AGENDA PORTLAND PLANNING BOARD MEETING

The Planning Board will hold a remote meeting on **Tuesday, February 22, 2022, 4:30 p.m.** This meeting will take place remotely using Zoom pursuant to the Remote Meeting Policy adopted by the Planning Board and as authorized under 1 M.R.S. 403-B because of the existence of an emergency or urgent issue that requires the committee to meet by remote methods. Allow your computer to install the free Zoom app to get the best meeting experience.

Memorandum Planning and Urban Development Department

To: Chair Stanley & Members of the Planning Board
From: Charles Tetelman
Date: February 18, 2022
Re: Portland Housing Authority - Riverton Rezoning
Project ID: ZN-001811-2021
Meeting Date: February 22, 2022

C2.0

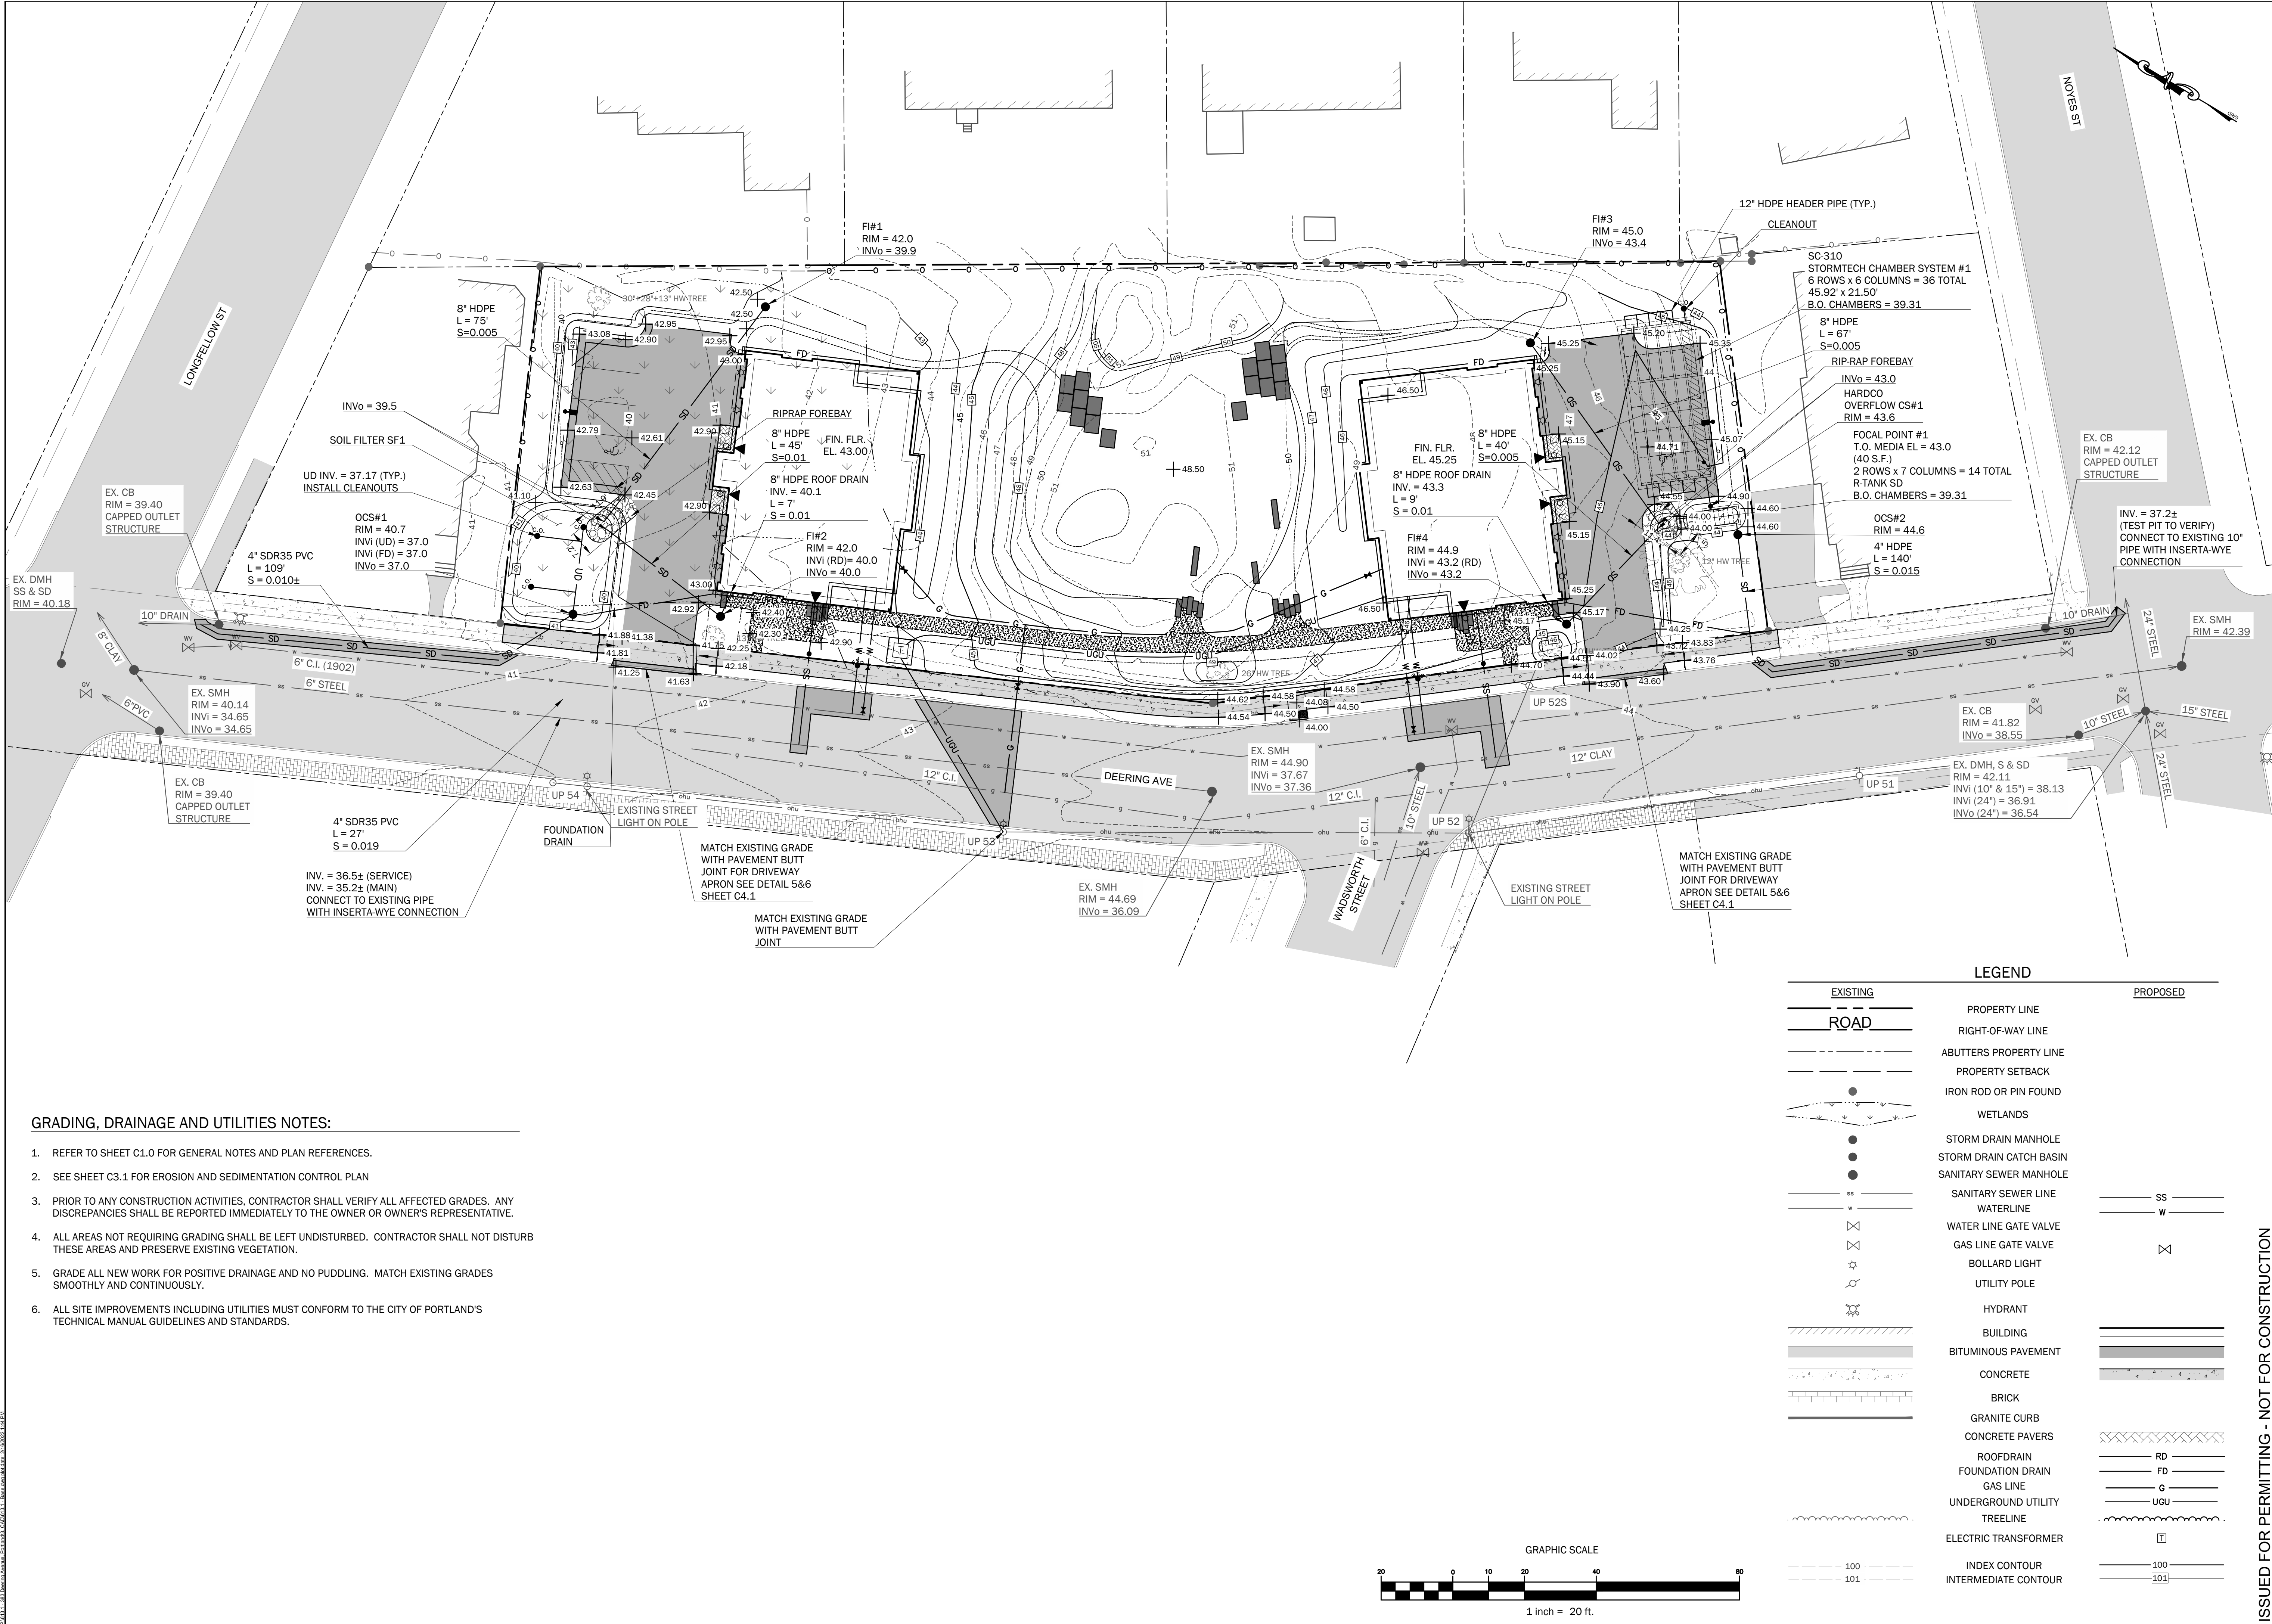
- The sidewalk material type should be clarified. The project is located in a concrete sidewalk district. Repairs are shown in the existing bituminous sidewalk for utility crossings and driveway entrances, but typically this would be required to be replaced with concrete to match the district. A bituminous sidewalk detail is provided on sheet C4.1, but is incorrectly labeled as reinforced concrete sidewalk.

The site distance measurements were added and are indicated on [Attachment 1 – Sheet C2.0](#).

The parking aisles have been increased to 24' and is reflected on [Attachment 1 – Sheet C2.0](#).
